# UNITED STATES PATENT AND TRADEMARK OFFICE

APPLICATION NO.	FILING DATE	FIRST NAMED INVENTOR	ATTORNEY DOCKET NO.	CONFIRMATION NO.
10/733,944	12/12/2003	Sten R. Gerfast		8717

### Office Action Summary

### DETAILED ACTION

As shown in the attached Figure 1, with annotations, a continuous single winding (105) being wound around three salient poles alternately in two opposite directions, as following:

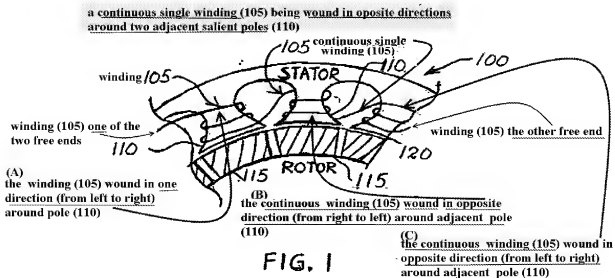
The drawings are objected to under 37 CFR 1.83(a). The drawings must show every feature of the invention specified in the claims. Therefore, the following must be shown:

(1) each salient pole including alternately wound coils coupled to form a single coil, as in claims 1 and 9, must be shown or the features canceled from the claims. No new matter should be entered.

(A) the single winding (105) being wound from *left to right* around a salient pole (110), which is located at the outer-left side in Fig 1, and one free end of the winding (105) is at this outer-left-side salient pole;

(B) the same continuous single winding (105) continuously being wound from *right to left* around adjacent salient pole (110), which is located at the middle in Fig 1; and,

(C) the very same continuous single winding (105) being continuously wound from *left to right* around adjacent salient pole (110), which located at the outer-right side in Fig 1, and the other free end of the continuous single winding (105) is at this outer-right-side salient pole.

Thus, all of Figures 1 of all the drawings, which were filed on 2/24/09, 04/02/06 and 12/12/03, show winding (105) being alternately wound, in opposite directions, around respective **plural** salient poles and the winding (105) being connected in series.

No drawings in the application show **each** salient pole including alternately wound coils coupled to form a single coil, as in claims 1 and 9.

Figure 1 only shows partial portion of the stator and the rotor; none of the drawings show a complete figure that illustrates the stator and the rotor having equal numbers of respective stator poles and rotor poles.

Corrected drawing sheets in compliance with 37 CFR 1.121(d) are required in reply to the Office action to avoid abandonment of the application. Any amended replacement drawing sheet should include all of the figures appearing on the immediate prior version of the sheet, even if only one figure is being amended. The figure or figure number of an amended drawing should not be labeled as “amended.” If a drawing figure is to be canceled, the appropriate figure must be removed from the replacement sheet, and where necessary, the remaining figures must be renumbered and appropriate changes made to the brief description of the several views of the drawings for consistency. Additional replacement sheets may be necessary to show the renumbering of the remaining figures. Each drawing sheet submitted after the filing date of an application must be labeled in the top margin as either “Replacement Sheet” or “New Sheet” pursuant to 37 CFR 1.121(d). If the changes are not accepted by the examiner, the applicant will
